MEMO

To: Loyd Smith, PE
Assistant County Engineer
Harris County Engineering Department (HCED)

From: Geoff Carleton, AICP
Sr. Principal, Traffic Engineers, Inc.

Re: Review of TxDOT Responses to HCED DEIS Comments

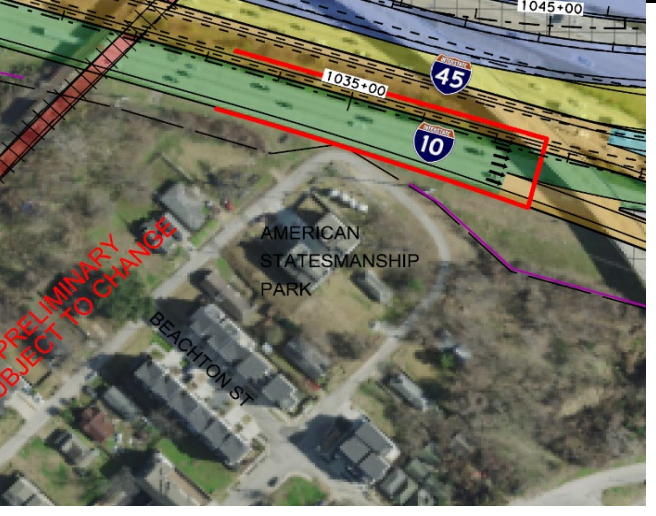
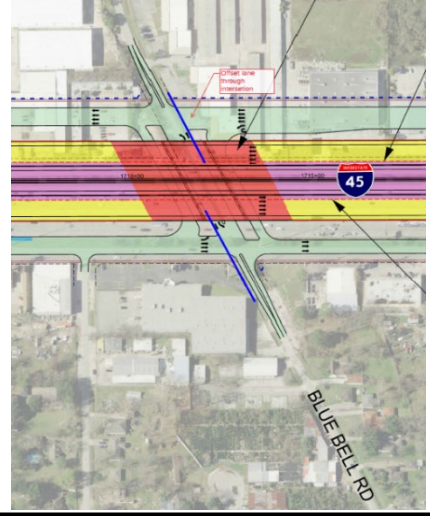
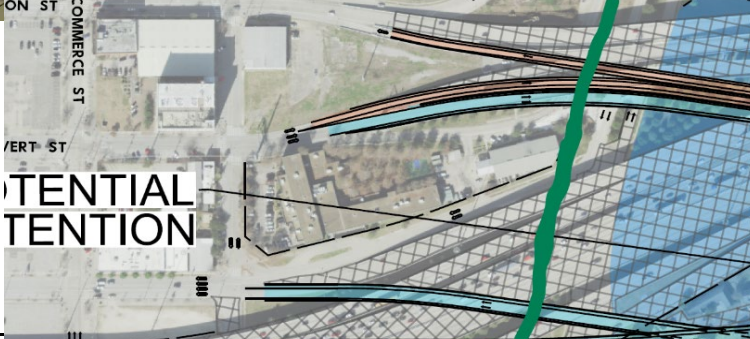
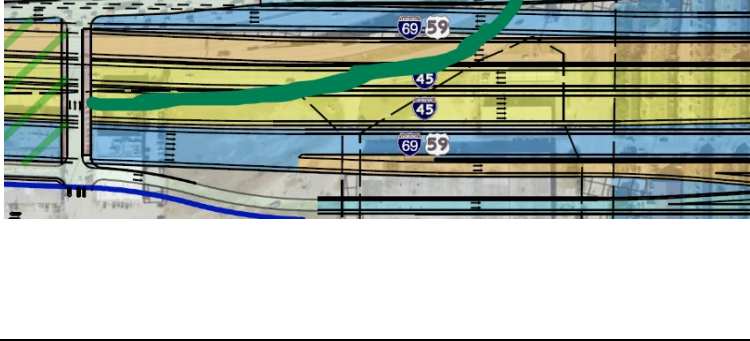
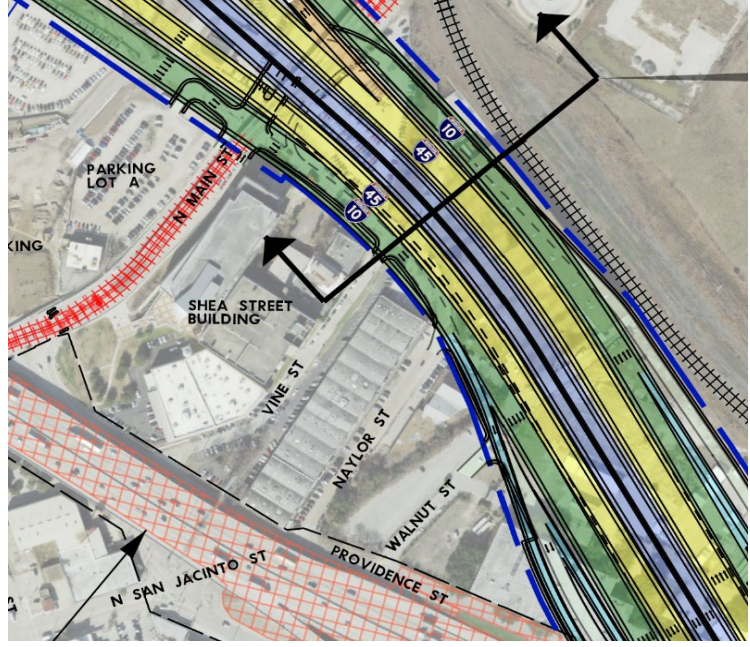
- Comment responses state that "TxDOT is coordinating and will continue to coordinate with the City of Houston to accommodate the City's future expansion of San Jacinto Street." (Comment 551). While this is a directionally positive statement, the most current FEIS schematics (December 2019) do not show San Jacinto extending to connect to or across the highway frontage roads on the north side of Downtown. Today, San Jacinto acts as a major connection between the I-10 East Freeway and Downtown; the street connects directly to and from ramps in both directions. The City of Houston's Major Thoroughfare & Freeway Plan also includes a proposed extension of San Jacinto Street/Jackson Street to Fulton Street in the Near Northside.

- The NHHIP project would move the highway alignment further north – where it no longer intersects with the existing terminus of San Jacinto Street – and the schematics do not show San Jacinto being extended to meet the new freeway. The only existing street extending to the freeway from the current terminus of San Jacinto in this area would Walnut Street. There is a street labeled Naylor

Street in the NHHIP schematic but according to Harris County Appraisal District the alignment appears to be entirely on private right of way. Both Walnut Street and the segment labeled Naylor Street are narrow alley-like corridors that primarily function as driveways to local buildings.

- The schematics show both Walnut street and Naylor connecting only to the eastbound frontage road, whereas San Jacinto currently extends across the highway to the westbound frontage road (Providence Street) and beyond. While it would be possible to extend San Jacinto to meet both frontage roads (crossing the proposed highway), this does not seem to be included in the project design or budget, nor does it show how this would work with a proposed San Jacinto underpass connection to the northside. This extension would also likely require acquisition of right-of-way that does not appear to have been documented in the FEIS. Extending San Jacinto to the westbound frontage road and also to the Near Northside should be considered as part of the design and implementation of Segment 3.

- Construct local streets, including San Jacinto Street, north of Downtown, that will be required to be reconstructed or extended due to realignment of the highway. At minimum, San Jacinto should be extended to meet the westbound highway frontage road. The commitments should also include the acquisition of any necessary right-of-way to extend San Jacinto to, or beyond, the westbound frontage road.

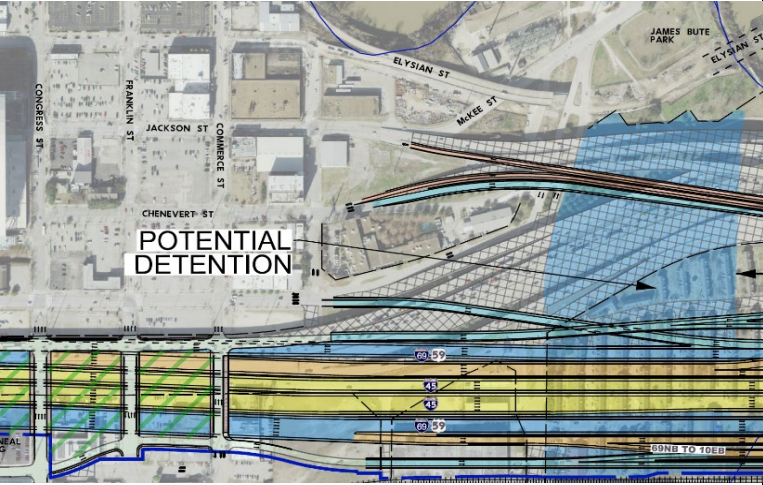
551	Harris County Engineering Department	7/27/2017	Email	<p>3. Significant Indirect Impacts to the County Courthouse / Criminal Justice Complex on the North Side of Downtown and A. Freeway and local street access to North San Jacinto Street, North Main Street, McKee Street and Hardy Street is either eliminated or left to other agencies to complete. The schematic is not sufficiently developed to fully understand the negative impacts of changes to the local street in the "warehouse district" near the I 10 / North San Jacinto intersection. A set of one way frontage roads are shown adjacent to the proposed freeway between Main Street and the McKee Street/Hardy Street one way pair, but there is incomplete definition of local street network restoration that must be included in TxDOT's construction in order to maintain connectivity to downtown via Main Street and North San Jacinto Street. The schematic drawings merely show existing TxDOT roadways at the north end of North San Jacinto Street being designated as "surplus ROW". Thus only the removal of vital connecting roadways is indicated, with the result that existing Main Street, North San Jacinto, Vine Street, Walnut Street, Nance Street and other roadways in that area are shown as unconnected street segments. This is not a sufficient level of project definition to ensure all impacts are evaluated and mitigated.</p>	<p>The proposed design would maintain connectivity between Northside and the Central Business District. All of the existing streets connecting the Northside to Downtown would remain and accommodations would be made for a future San Jacinto St. connection. Improvements also include railroad underpasses at McKee St. and Jensen Dr.</p>	Not Addressed or Not Resolved	<p>No additional clarification provided as part of FEIS.</p>

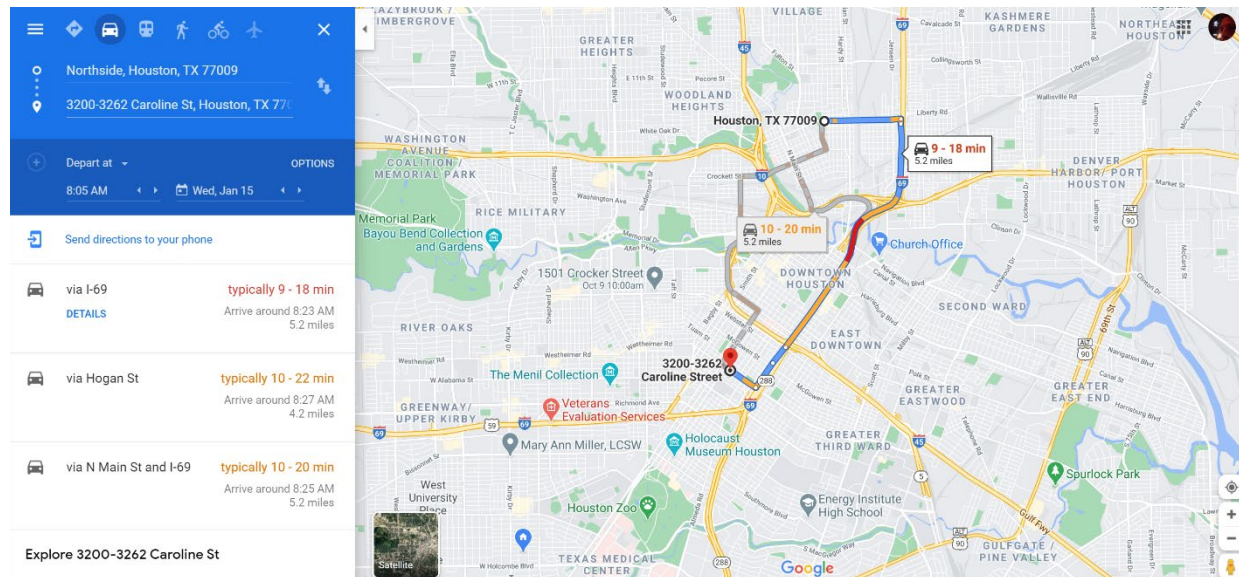
- b. The travel demand model does not appear to meet the reasonableness test. The model does not accurately capture the impact on total trips and trip mode split caused by delay assumptions and likely significantly overstates project benefits.

- i. The estimated travel times for no build are not reasonable;
 - 1. Examples of these trips are shown in the Travel Time Table below which was provided in the [NHHIP Project Facts & Highlights](#).

2. As driving trip speeds drop significantly, driving trip demand will also decline or people will choose different, faster modes to make their trip; Travel Demand Models often do not factor this into the modeling assumptions accurately.

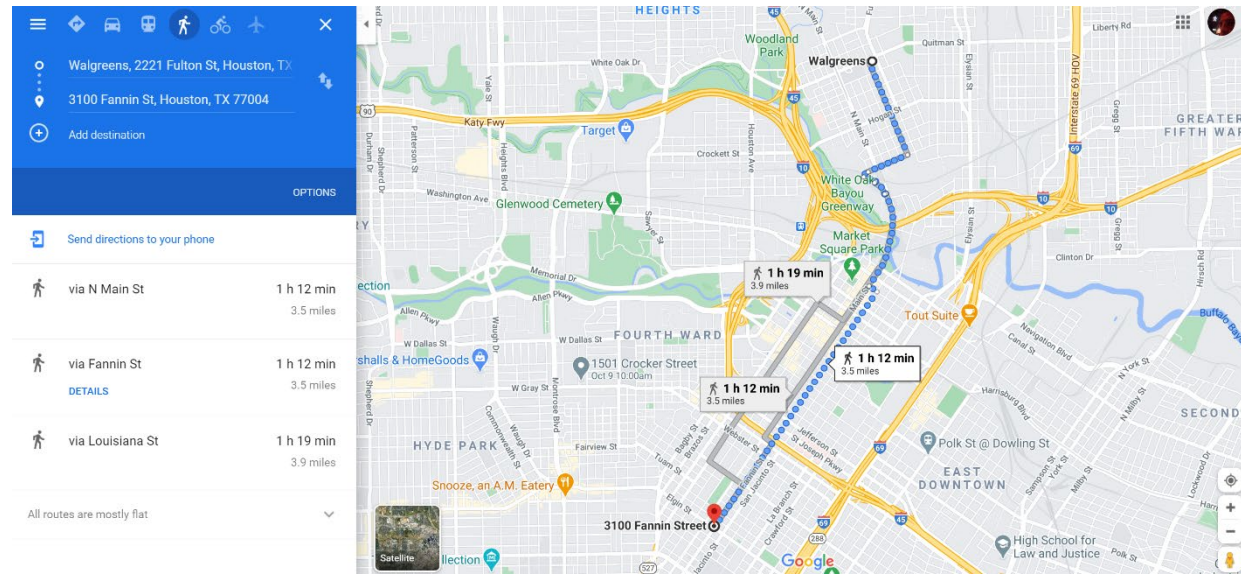
1. This trip is assumed to take 103 minutes in the No Build and 16 minutes with the NHHIP.
 2. Because exact locations are not provided by the Table, we can compare at a trip from the intersection of Fulton at Quitman in Near Northside to the intersection of Caroline at Elgin in Midtown which are both central to their respective districts.

3. Existing driving trip travel times from Google Maps in January 2020 are estimated to take 9-18 minutes and cover a distance of 5.2 miles. As the crow fly distances between these two points is 3 miles.

4. The No Build travel time assumption of 5.2 miles in 103 minutes would imply a travel speed of 3 mph.
5. According to Google Maps, making this trip via walking would take 31 minutes less (72 minutes vs. 103 minutes).

6. Taking this trip by METRO's Red Line LRT would take 29 minutes (14 minutes walking, 15 minutes riding on the train)
 7. Clearly fewer people would make this trip at his time via driving if these were the choices.

Section 2) Base line model Assumptions for traffic growth have not been supported by actual data.

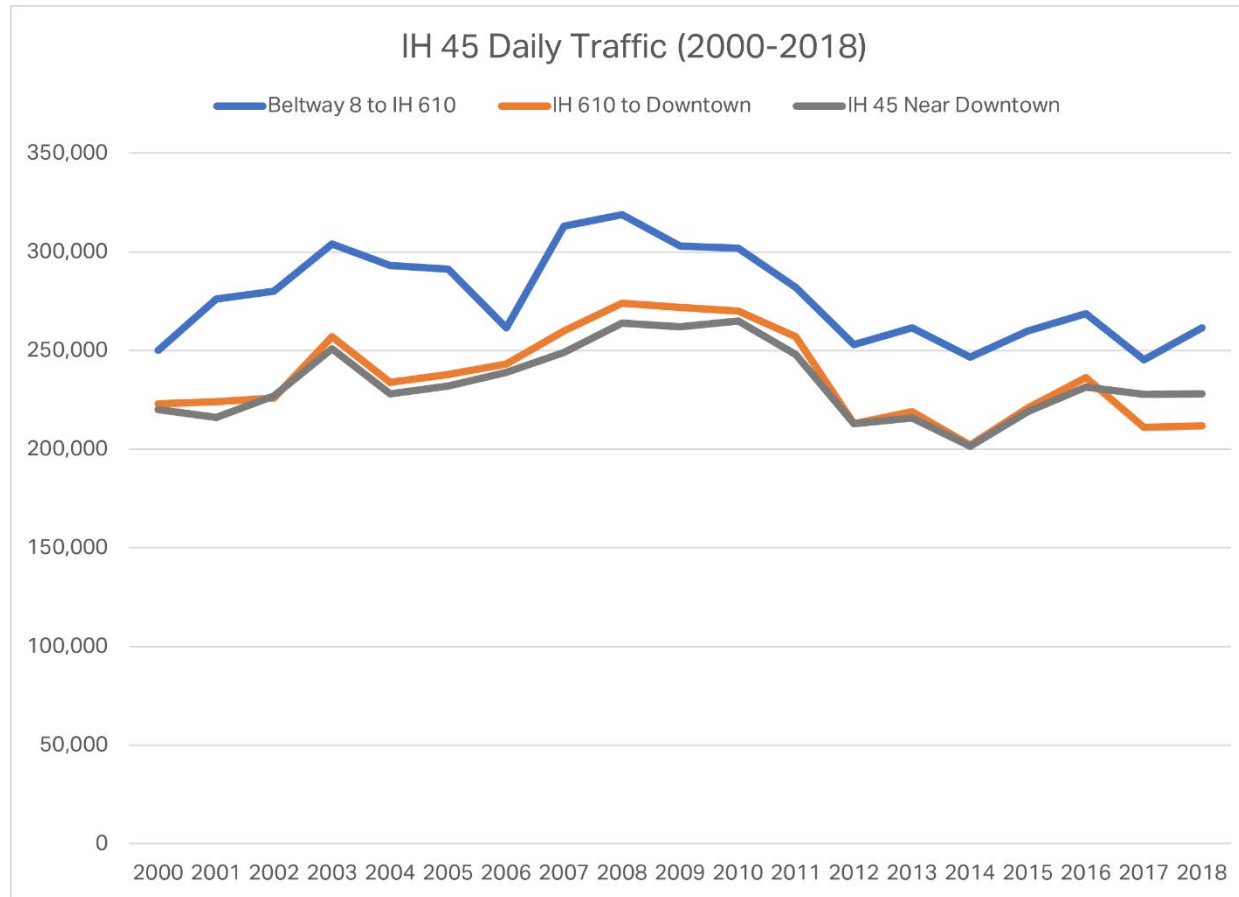
a. Traffic volumes on IH 45 have been essentially flat for two decades; (Source: TxDOT Statewide Planning Map Data)

- i. Beltway 8 to IH 610 (0.2% Compound Annual Growth Rate (CAGR))
- ii. IH 610 to Downtown (-0.3% CAGR)
- iii. IH 45 at Downtown (0.2% CAGR)
